Responses to MAC-2014 Recommendations on Low-Energy RHIC electron Cooling (LEReC)

Alexei Fedotov for the LEReC team September 20-21, 2015

Example of ongoing laser pulse shape optimization with the GPT code (Colwyn Gulliford, Cornell)

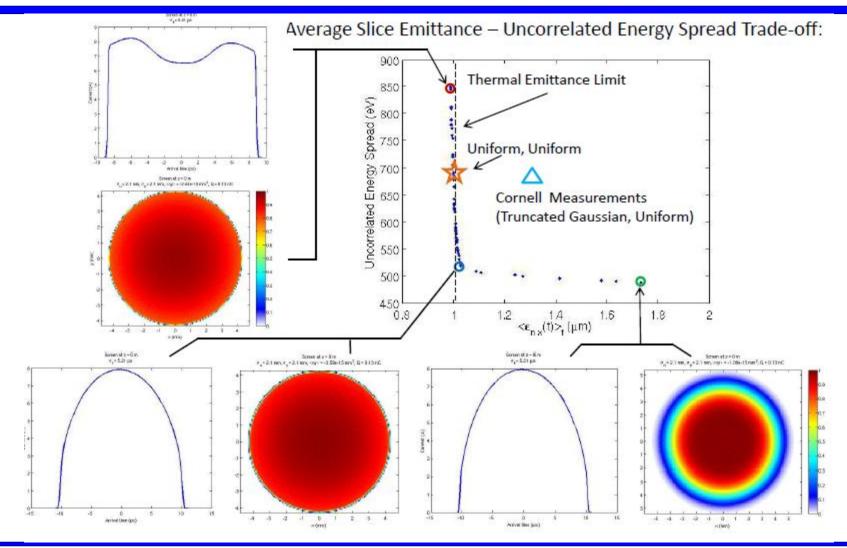
- For further refinement of low energy electron cooling, the choice between SRF and DC guns should be made in the near future.
- Improve the simulation by addressing the deficiencies mentioned above and possibly adopting another simulation code.

The 3-D space charge simulation code General Particle Tracer (GPT) was adopted for realistic simulations. The GPT code is now installed and running at BNL. Also collaboration with Cornell was established. Realistic simulations of LEReC beam transport with the field maps for every element are in progress.
